**DEFENSE NUCLEAR FACILITIES
SAFETY BOARD**

Staff Report

August 16, 2019

Safety Basis for the Plutonium Facility at Los Alamos National Laboratory

Figure B-1. ICRP-71 Annexe D.2 Recommended Assignments against Park’s Data

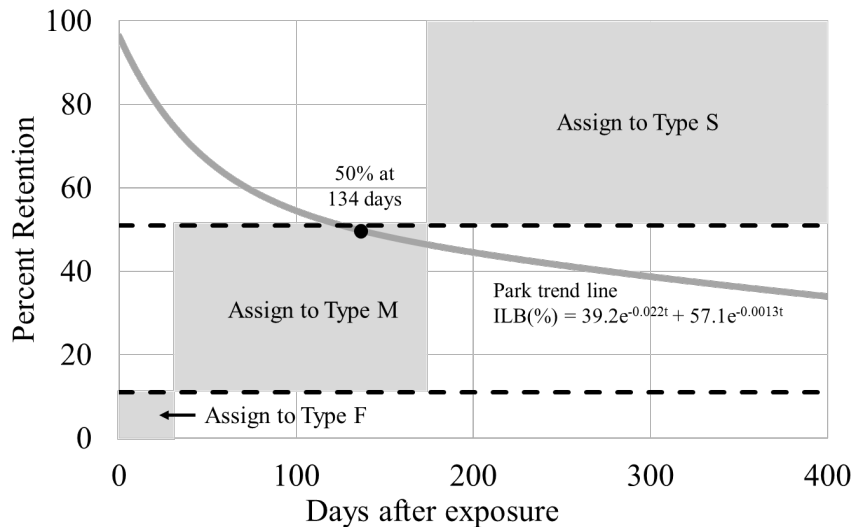
The ESS references a study by Park [23] as the basis for establishing the 800°C threshold for applying the intermediate solubility class. The Park report presents measured lung retention as a function of time for dogs that were exposed to ²³⁸PuO₂ through inhalation. Based on their review of the Park data, LANL safety basis personnel concluded that the ²³⁸PuO₂ material used in the experiments (i.e., heated to 800°C for two hours) exhibited behavior consistent with Type S material. They based this conclusion on a determination—without documenting their rationale—that the Park data demonstrated a 50 percent retention time of 400 days.

Annexe D of ICRP-71 provides guidance for assigning lung clearance types to radionuclides based on experimental data. Figure D.2 in ICRP-71 establishes regions for assigning lung clearance types to experimental data of lung retention behavior. Figure B-1 below overlays Park’s fit of the experimental data (initial lung burden [ILB]) with Figure D.2 of

ICRP-71. The resulting figure with the corresponding trend line demonstrates that 50 percent lung retention occurs at 134 days, which the ICRP guidance indicates is consistent with Type M material.

The staff team is also concerned that LANL has not provided a technical basis for the application of the intermediate dose conversion factor to other forms of HS-Pu including oxalates, non-fired granules, and hydroxide cakes. ICRP does not provide guidance for ^{238}Pu in these forms nor does it relate their solubility characteristics to ^{238}Pu oxides. Without a firm technical basis, the staff team believes that LANL should be using ICRP’s recommended default of Type M.
